## **Appendix C: Justification of Deviation Zone Excursions**

## 1.0 Explanation for Proposed Deviation in EM&CP Segment 17

As part of the EM&CP filing for Segment 17, the Certificate Holders are proposing minor areas of permanent cable installation which will be outside of the ADZ associated with the Putnam Station Transitional Horizontal Directional Drilling (HDD) and the Congers Transitional HDD. This memorandum provides the required supporting materials necessary for DPS staff to review and

**Figure C2**  
**Permitted Deviation Zones**

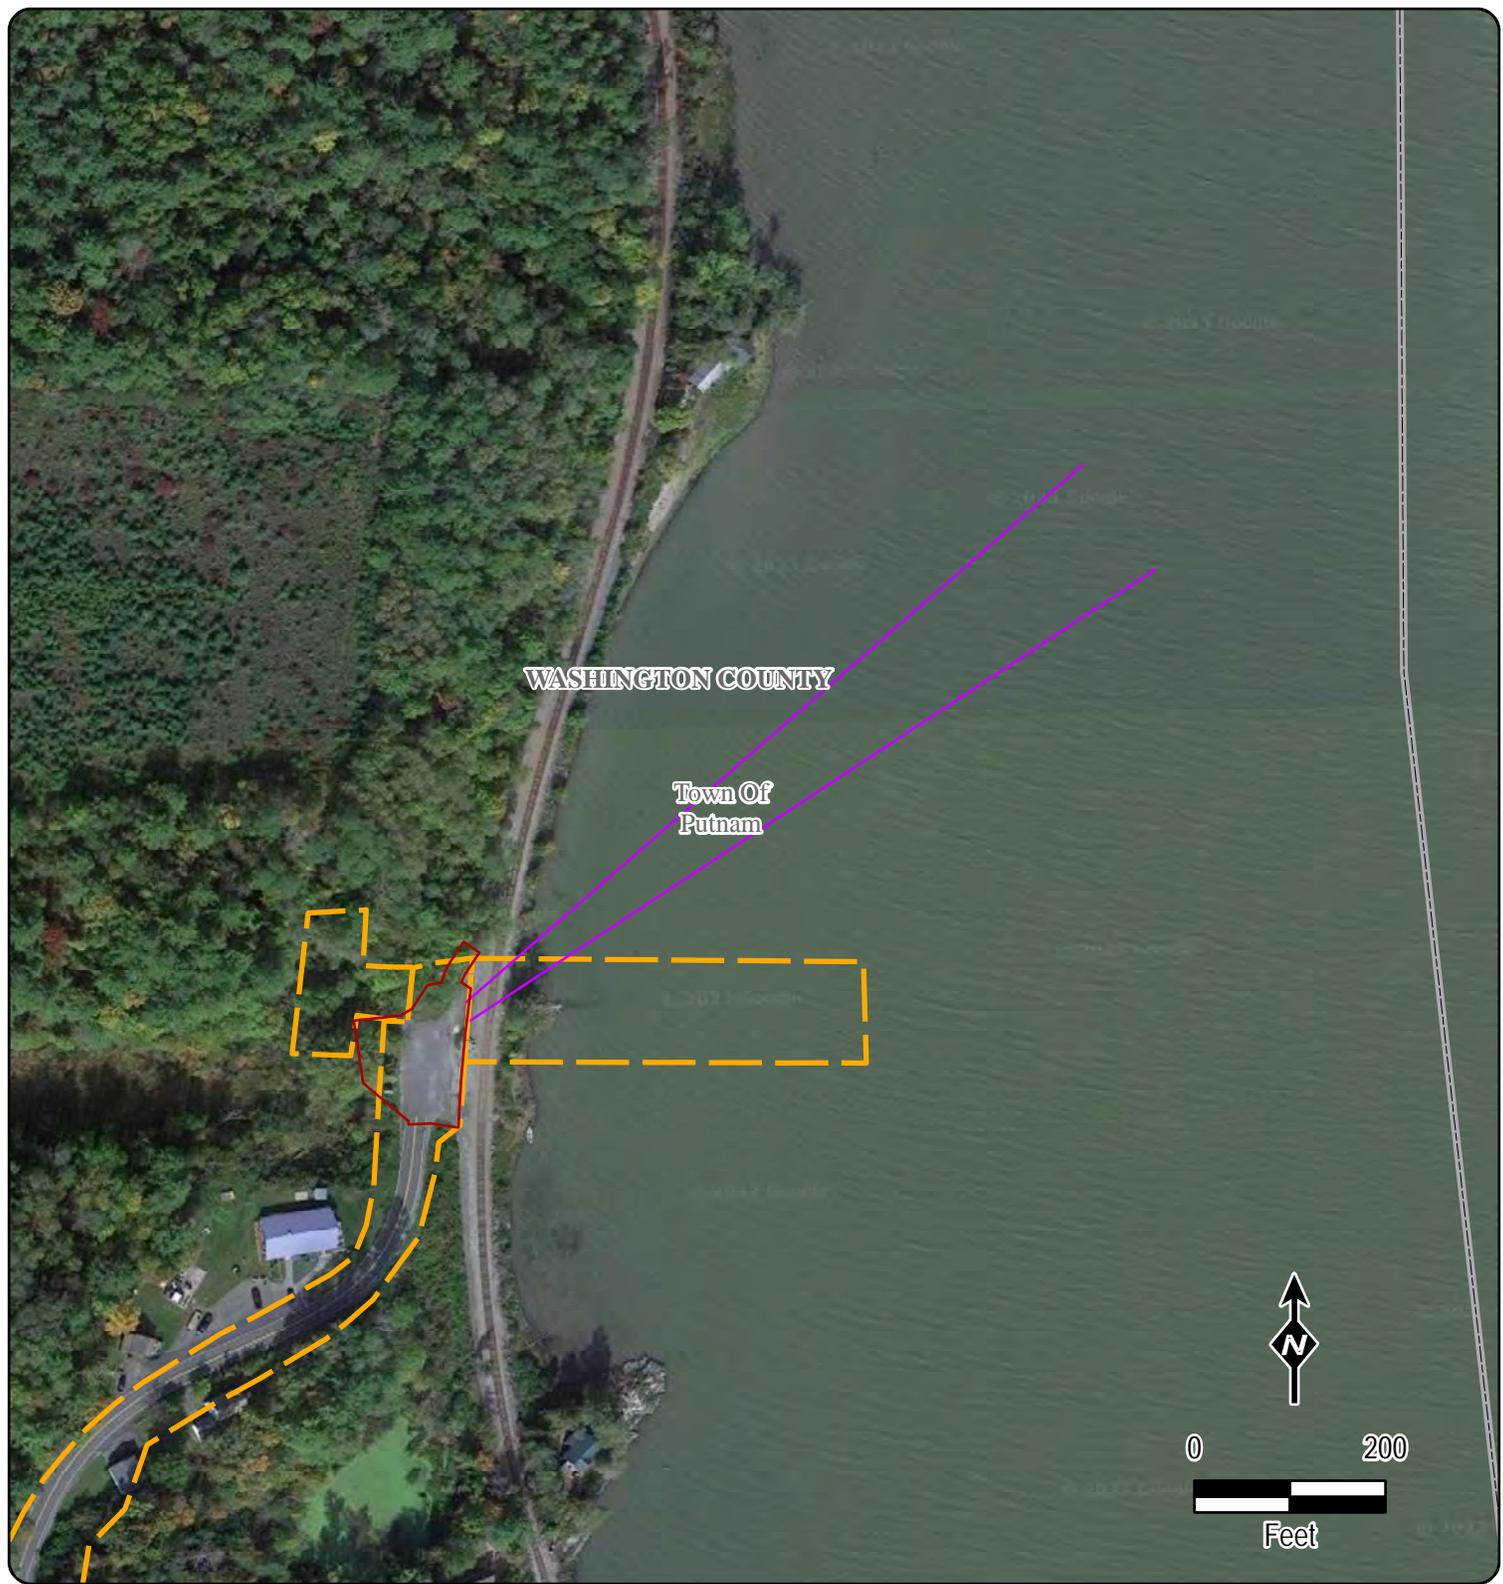
The Exceedance Area is located in a small area at the northeast corner of the LOD, where the southern HDD entry pit is proposed (Figure C2). In this area, the HDD conduits have been extended further to the west and south, slightly outside of the ADZ. The southernmost cable is a maximum of 10 feet south of the ADZ. Pursuant to Condition 138, each EM&CP filing must include a "detailed map or maps showing...the anticipated ultimate location and boundary of the Facility ROW". A detailed map showing the location and boundary of the Exceedance Area and Facility ROW is depicted in the EM&CP Plan and Profile drawings (see Attachment A of the EM&CP).

Due to the proposed location of the transition vault, the HDD conduits have been moved slightly to the west and south. This minor modification will enable proper tie-in at the transition vault. This change will also ensure that all construction activities and permanent structures remain within the LOD and within the parcel owned by Isabella Rose Reality, LLC, the landowner with whom CHPE has an agreement for this installation.

## Figure C1 Permitted Deviation Zones

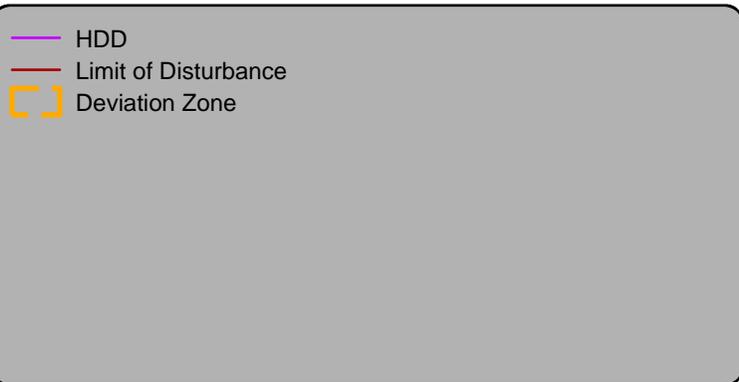
The Exceedance Area is located along the northeastern portion of the project area, where the permanent HDD cable route deviates slightly north of the ADZ, after crossing under the Canadian Pacific Railway (Figure C1). The northernmost cable begins to deviate just to the east of the Railway within the slope leading to Lake Champlain, while the southernmost cable begins to deviate within Lake Champlain. The northernmost cable is proposed approximately 300 feet north of the easternmost edge of the ADZ. Pursuant to Condition 138, each EM&CP filing must include a "detailed map or maps showing...the anticipated ultimate location and boundary of the Facility ROW". A detailed map showing the location and boundary of the Exceedance Area and Facility ROW is depicted in the EM&CP Plan and Profile drawings (see Attachment A of the EM&CP).

Original designs and drawings planned for a transition vault connection at 90 degrees, with the HDD conduits proceeding due east and the buried overland cables proceeding due south. This 90-degree connection at the transition vault is not technically feasible. Additionally, due to the proximity between the transition vault and the Canadian Pacific Railway, this HDD route would result in minimal vertical ground cover between the Railway and the HDD conduits, which is not desirable from the perspective of either Canadian Pacific or the Certificate Holders. Communication with Canadian Pacific confirmed that a deeper depth of cover was necessary to protect the integrity and safety of the railway.

To avoid these undesirable complications, the HDD conduits have been re-routed to the northeast. This adjustment in HDD route alleviates the 90-degree bend at the transition vault. Additionally, this route creates additional vertical ground cover between the HDD conduits and the railway. Thus, this change is necessary to ensure adequate land-to-water connection at the transition vault and to avoid adverse impacts to the Canadian Pacific Railway.
